## SERVICE INSTRUCTION

# Introduction of new oil radiator/-sets on ROTAX® Engine Type 912 i, 912 and 914 (Series)

ATA System: 79-00-00 Lubrication system

Fig. 2

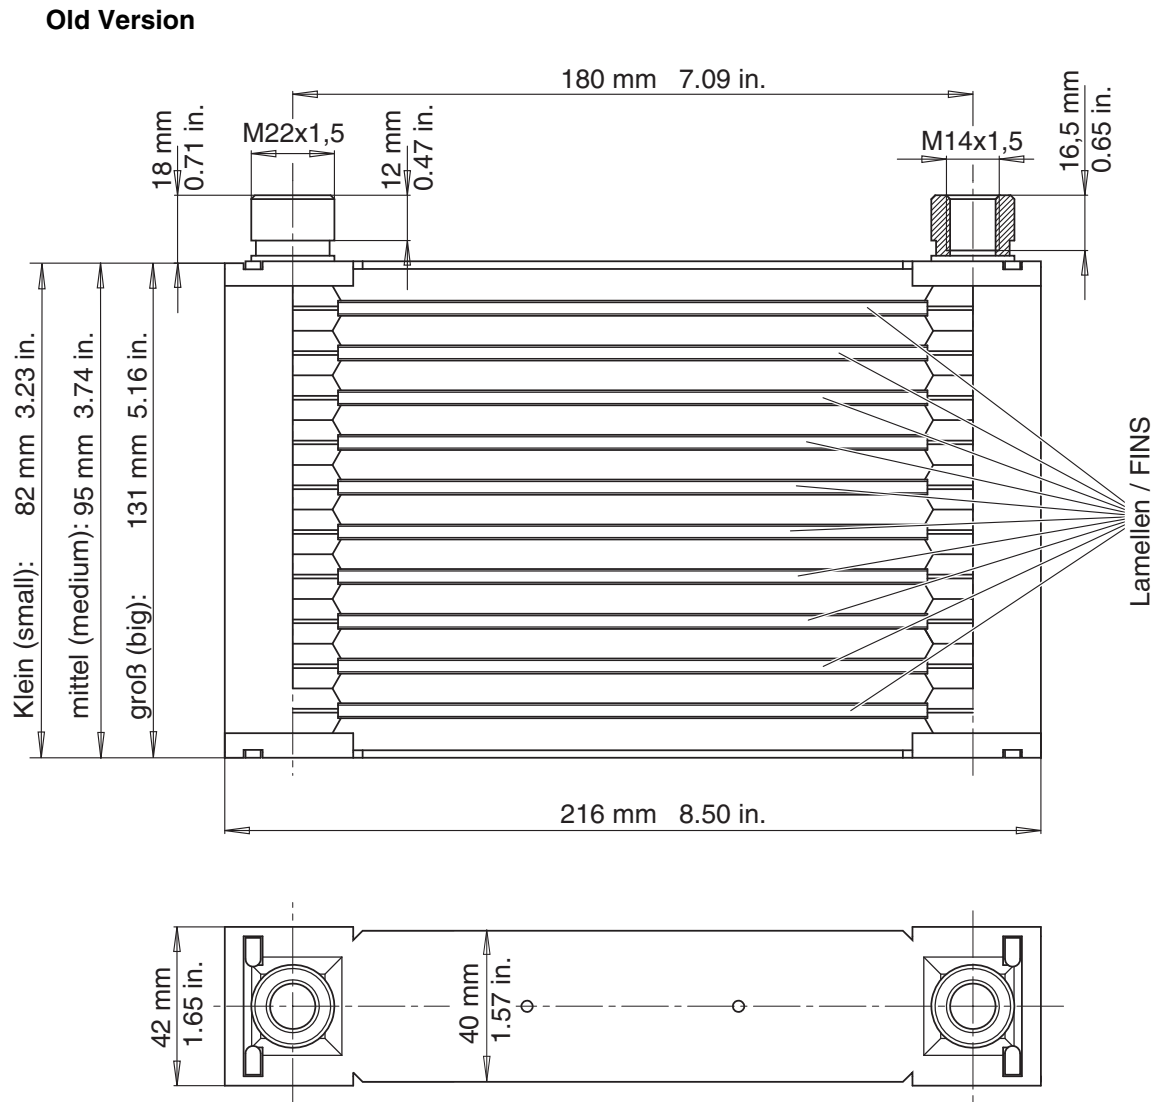
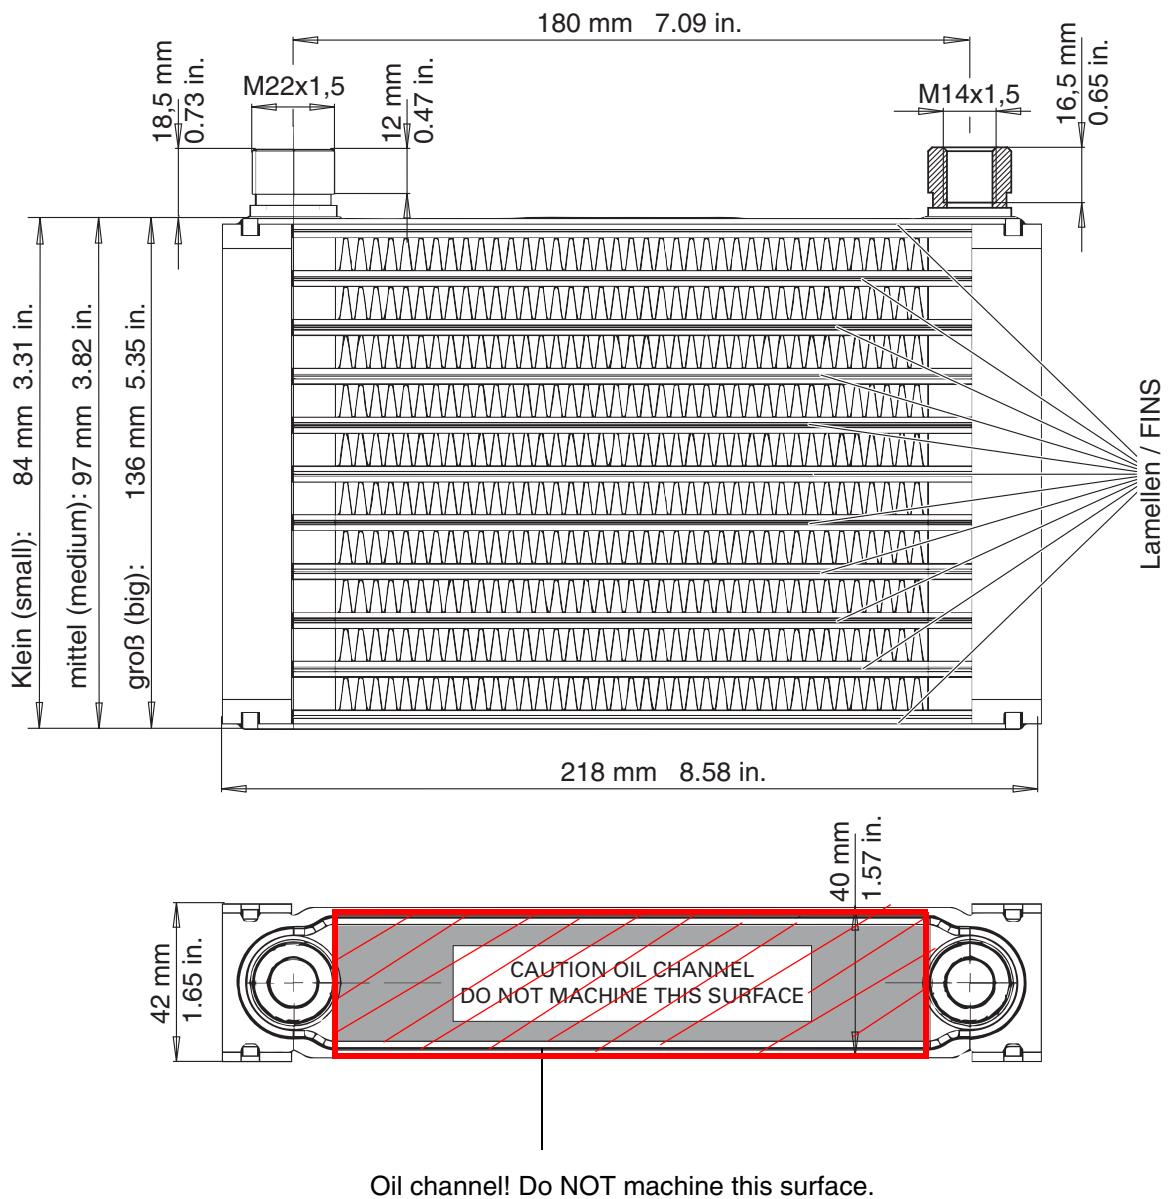
In comparison with the current oil radiators (part no. 886022/886023/886024) the following changes were necessary:

- Modifications in the dimensions of the oil radiator
- Increase of the number of radiator fins

- see modified outer dimensions as shown in [Fig. 2](#).

Any changes to oil radiator are not permissible.  
See [Fig. 2](#).

- see different position of the fins.
